**RE: ADDENDUM TO SAMPLING AND ANALYSIS WORK PLAN  
WOODWORTH LAKEVIEW FACILITY REMEDIATION  
2800 104<sup>TH</sup> STREET COURT SOUTH, LAKEWOOD, WASHINGTON  
FARALLON PN: 188-002  
VCP IDENTIFICATION NO: SW1012**

**Re: Review of September 25, 2017 "Sampling and Analysis Work Plan, Lakeview Facility, 2800 104<sup>th</sup> Street Court South, Lakewood, Washington, VCP Identification No. SW1012"**

**FIGURE 2**

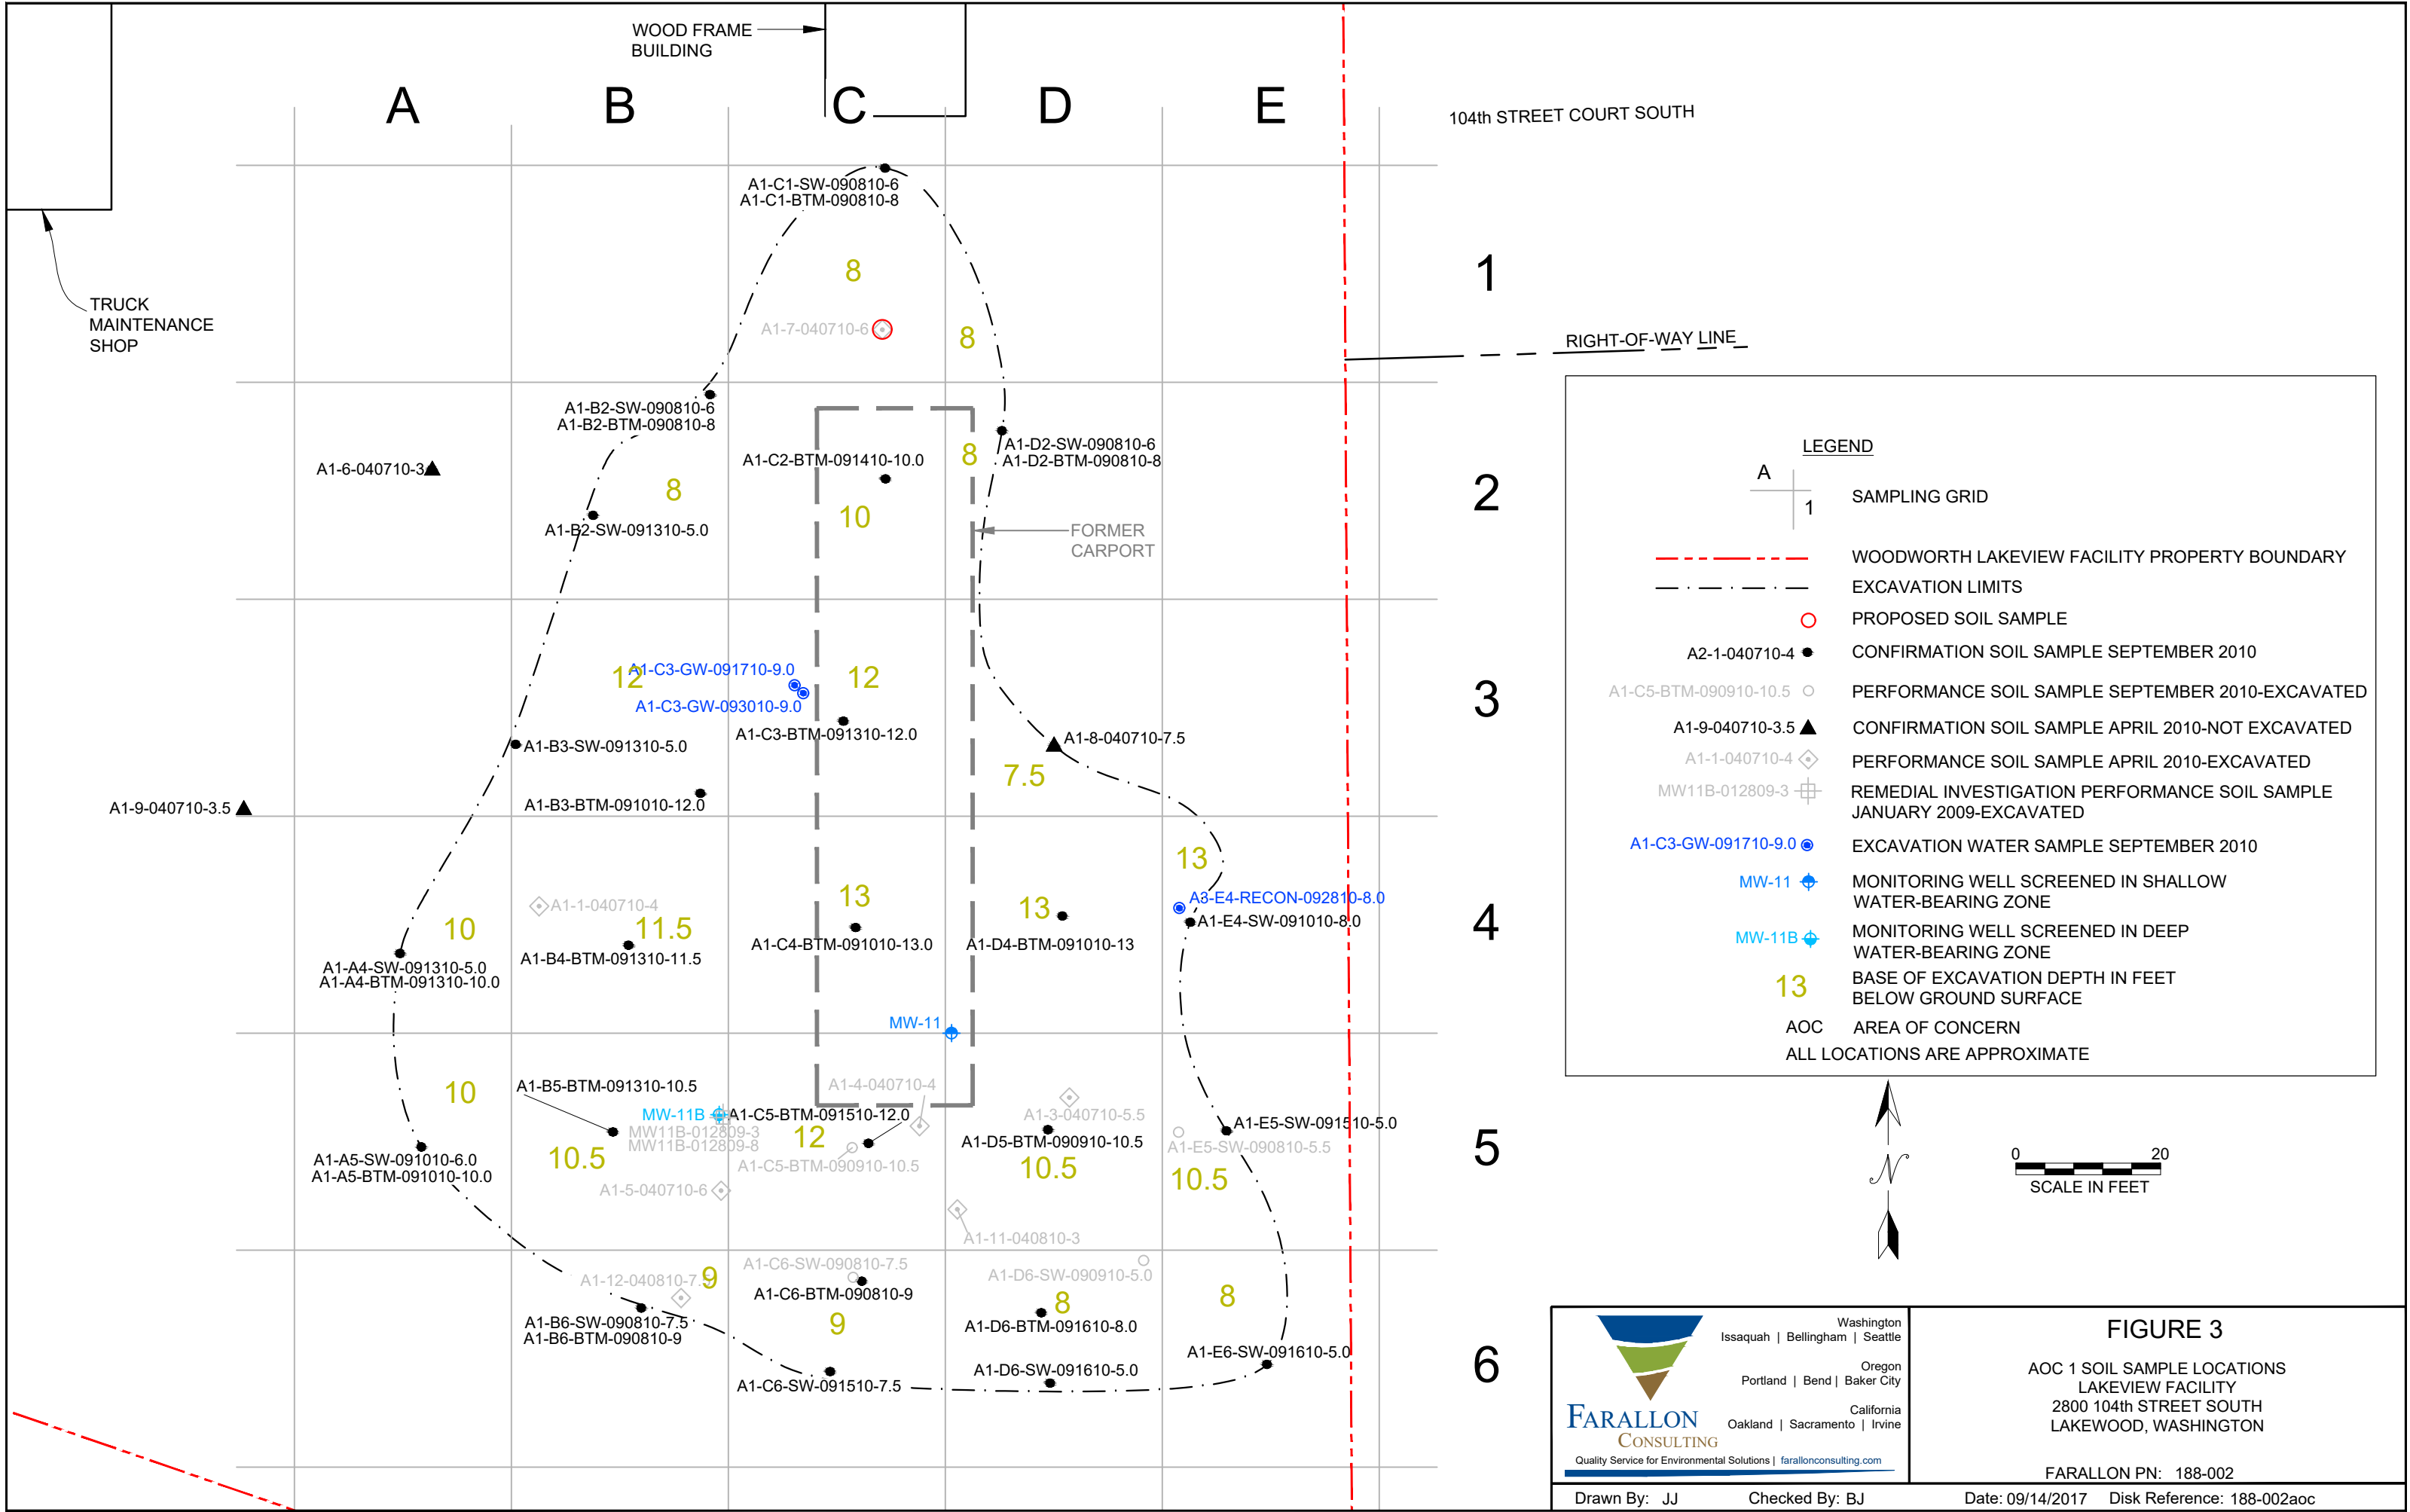
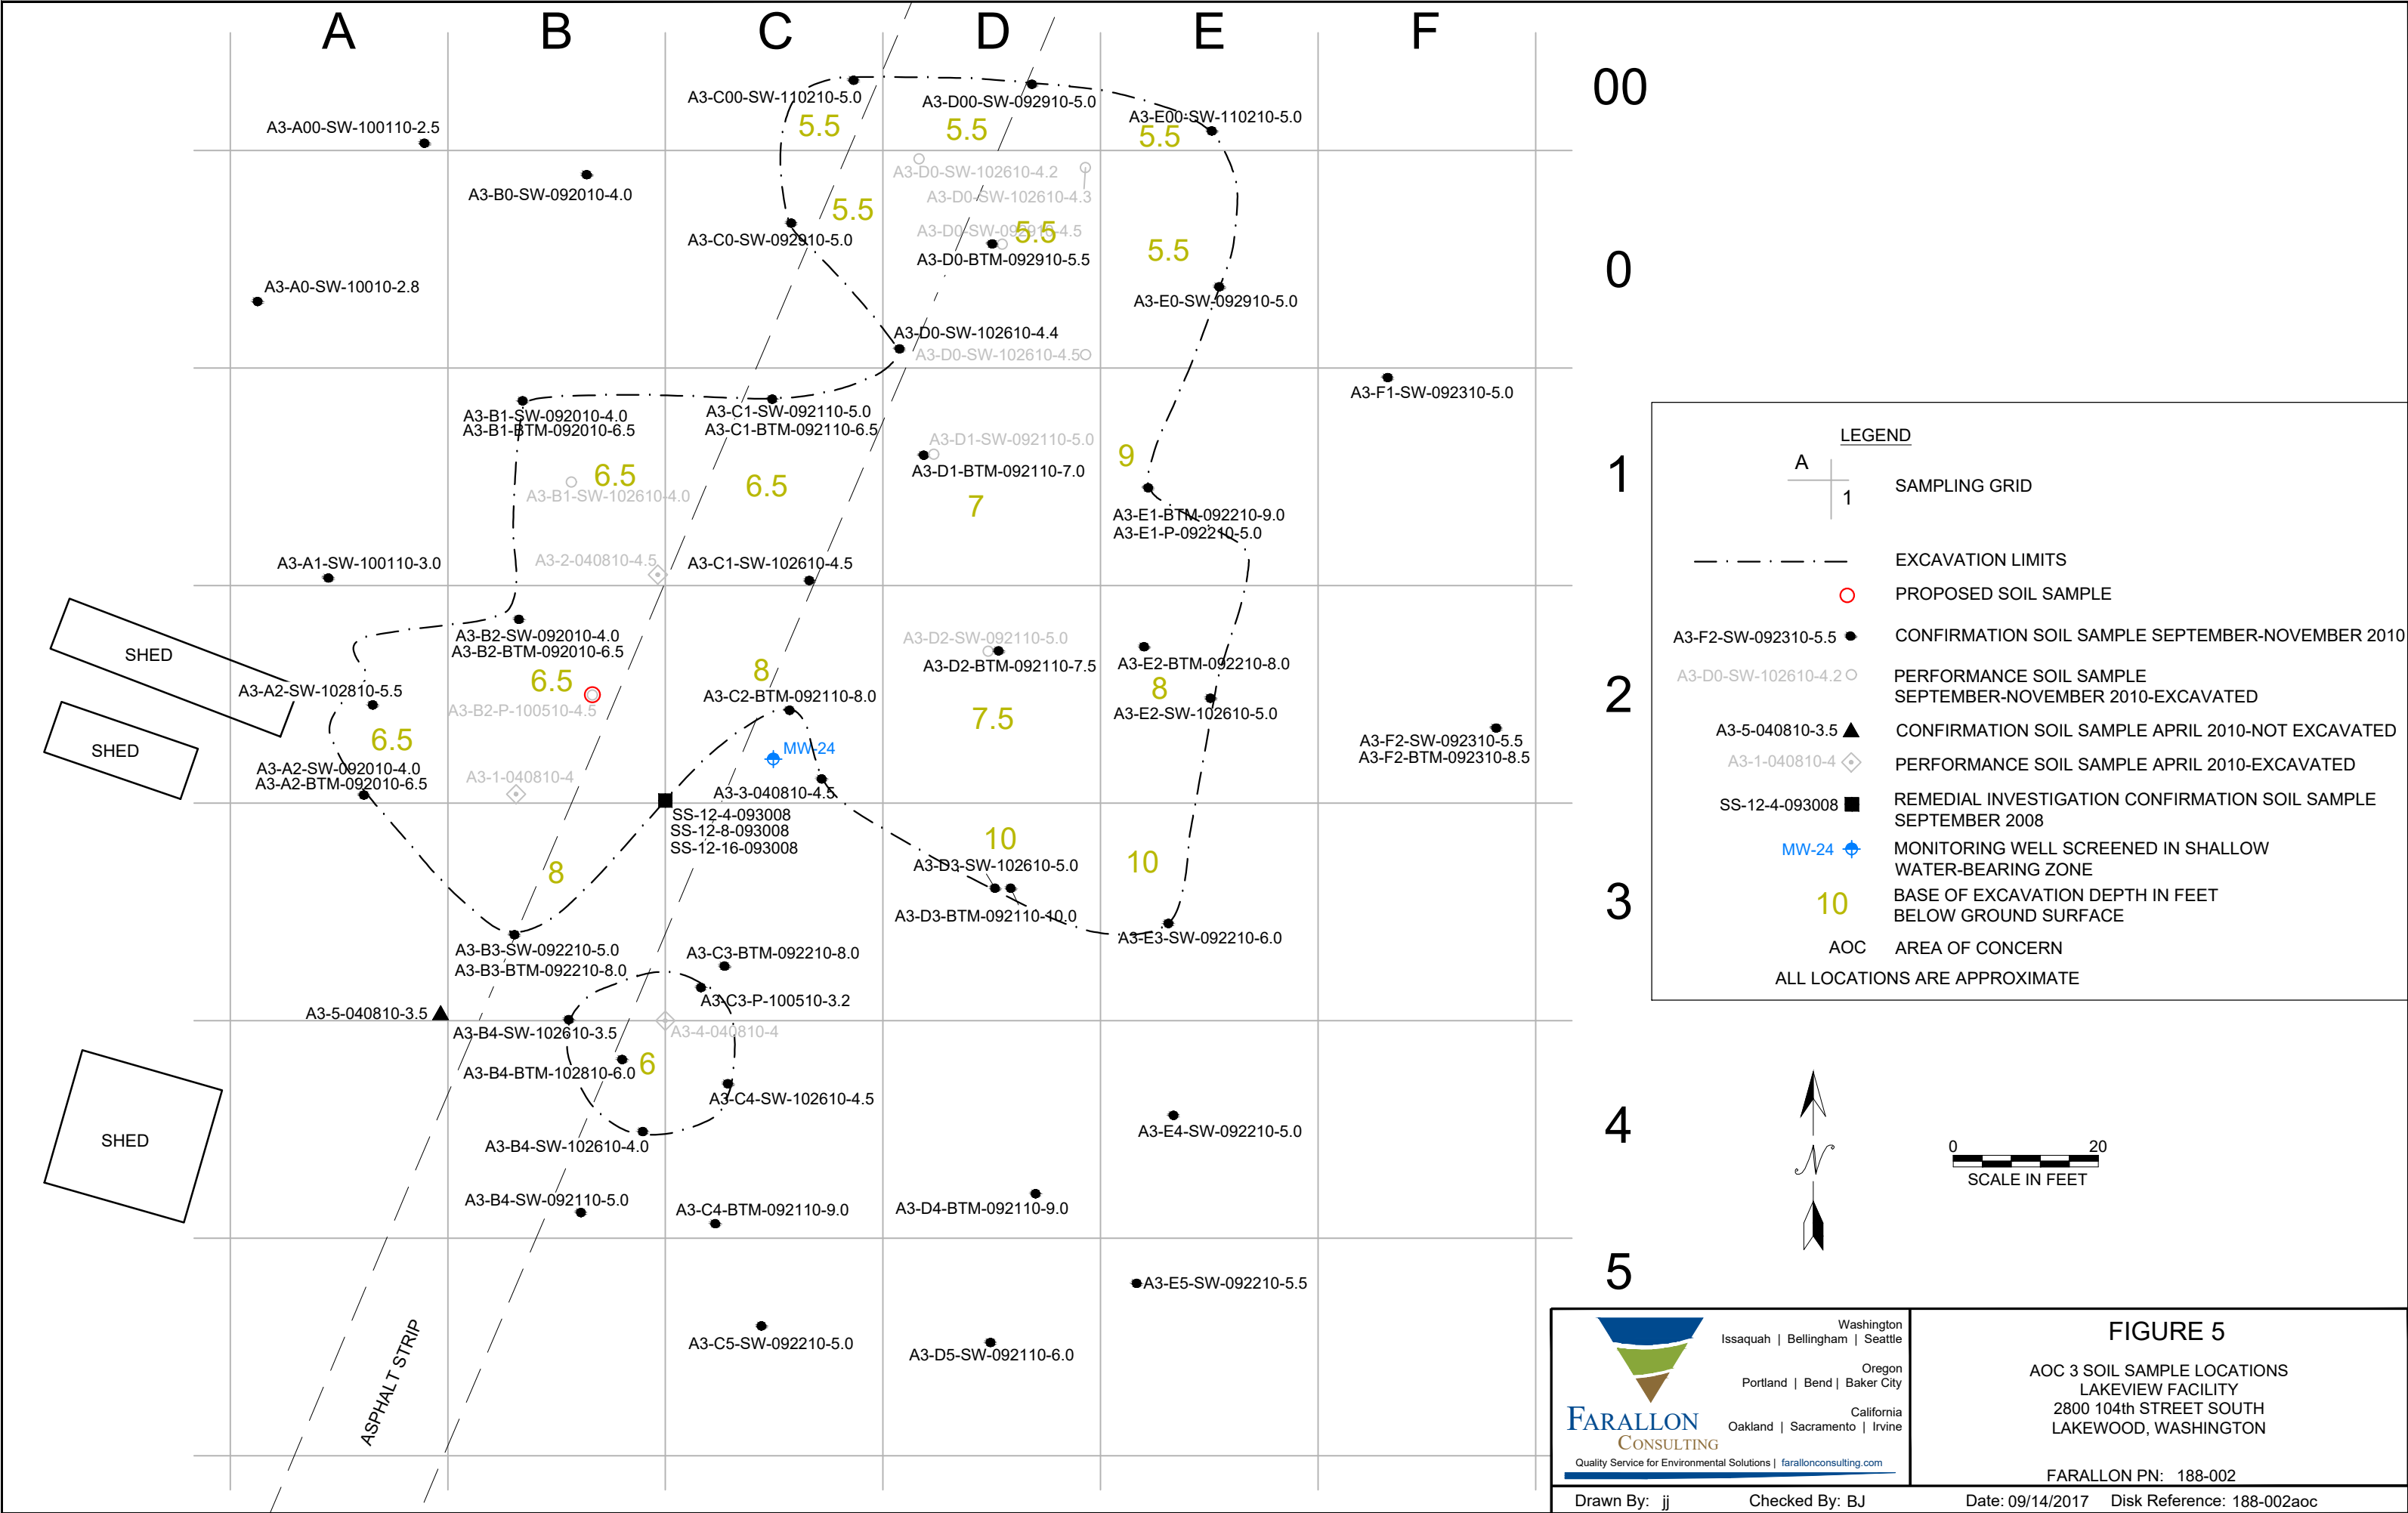
Ecology requested collection of soil samples for laboratory analysis for polychlorinated biphenyls (PCBs) and polycyclic aromatic hydrocarbons (PAHs) in Areas of Concern (AOC) 1, 2, and 3 and

the areas indicated as the asphalt plant, tar tank, and hot mix plant (Figure 2). The scope of work will include:

Ecology requested collection of groundwater samples from the locations identified in the SAWP for analysis for VOCs, rather than for analysis for halogenated VOCs; and that monitoring wells MW-10B, MW-12B, and MW-21 and remediation wells AS-9 and AS-10 be included in the groundwater monitoring and sampling field program. Ecology requested that monitoring wells MW-9B and MW-12B be included in the groundwater monitoring and sampling field program, contingent upon detection of trichloroethene in monitoring well MW-23 (Figures 2 and 7). Groundwater samples collected from monitoring well MW-21 will also be analyzed for DRO and ORO.
